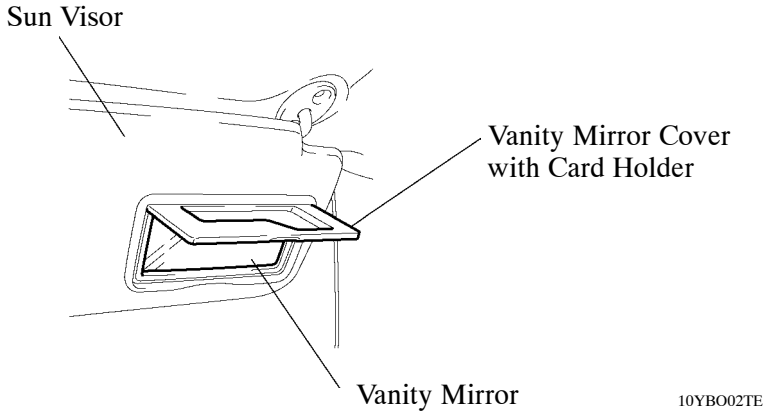
The vanity mirror on the sun visor provided on models other than those for China has been changed as shown in the table below.

Model	New FJ CRUISER	Previous FJ CRUISER
Driver vanity mirror	Vanity mirror cover with card holder is provided.	Not available
Front passenger vanity mirror	Vanity mirror cover with card holder is provided.	Vanity mirror cover is not available.
